S.B. No. A320-21-1042 REV. 1

TITLE : AIR CONDITIONING - RECIRCULATION FAN POWER SUPPLY - REPLACE SIZE

20 TERMINAL BLOCK BY SIZE 16 IN 103VU.

CHANGE NOTICE No.: 1.A.

Modification to Wiring in Relay Box 103VU Figure 1, Sheet 1 of 2

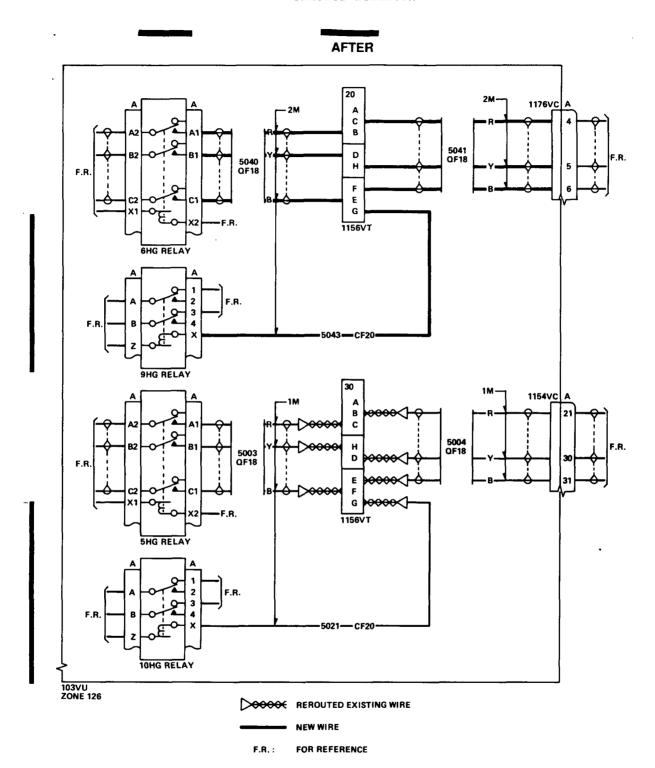
On 103VU, damage of modules in the cabin fan electrical circuit has been experienced on aircraft 201 (before delivery). This was due to unexpectedly high electrical loads being passed through adjacent modules.

This Service Bulletin calls for the replacement and relocation of terminal block modules 1156VT 30 and 31 used in the cabin fan electrical circuit.

These size 20 modules will be replaced by size 16 modules. The modification covers also the connection of the 12 cables associated to these modules.

BEFORE

WIRE TO BE REROUTED

(1) Modify the equipment and wiring in relay box 103VU, zone 126.

- (a) Open the relay box door.
- (b) Remove from the mounting rail of terminal block 1156VT:

- 1 module in position 30 (discard)
- 1 module in position 31 (discard)
- 1 dummy module in position 20 (retain)

(c) Install on the mounting rail of terminal block assy 1156VT:

1 module NSA937901M16-06, in position 30 1 module NSA937901M16-06, in position 20 1 dummy module NSA931901FM, in position 31

- (d) Remove the wires shown on lines 14 thru 19 of Figure 2 and line 4 of Figure 3.
- (e) Modify the connection of wires shown on lines 1 thru 12 of Figure 2 and lines 1 and 2 of Figure 3.
- (f) Install the wires shown on lines 20 thru 25 of Figure 2 and line 5 of Figure 3, D9000095007996, route them with wires that are in the aircraft.
- (g) Cut the wires to the necessary length, crimp the terminals and connect them.
